DOCTORS HOSPITAL RADIOLOGY SERVICES, INC.

January 19, 1983

In response to your letter of December 10, 1982 concerning our amendment request the following addition information is supplied:

In support of our request for the use of X3-133 gas the following information is submitted.

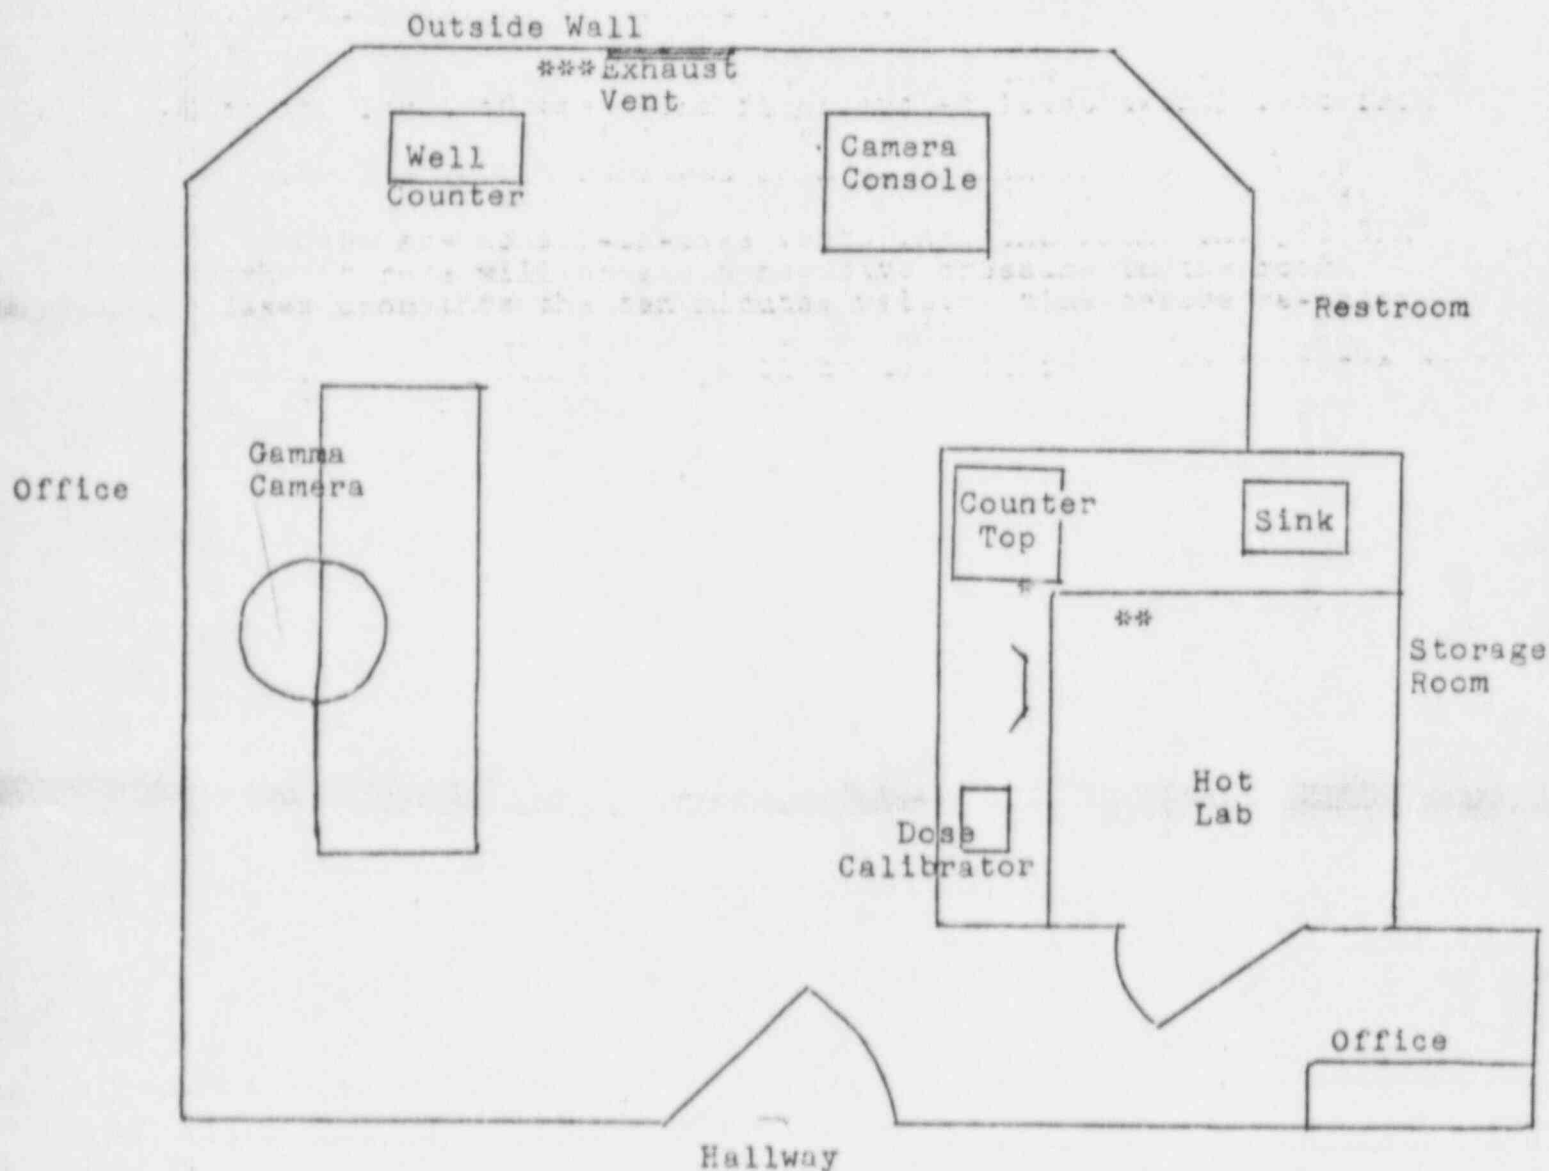
*Isotope Storage Area. All radioactive materials will be stored behind lead bricks.

** Waste Storage Area. All radioactive waste will be stored under the counter top with proper lead shielding.

*** Xenon Exhaust Vent. The exhaust rate is 300CFM above the intake rate. There are no air intakes within 12 feet of the exhaust vent.
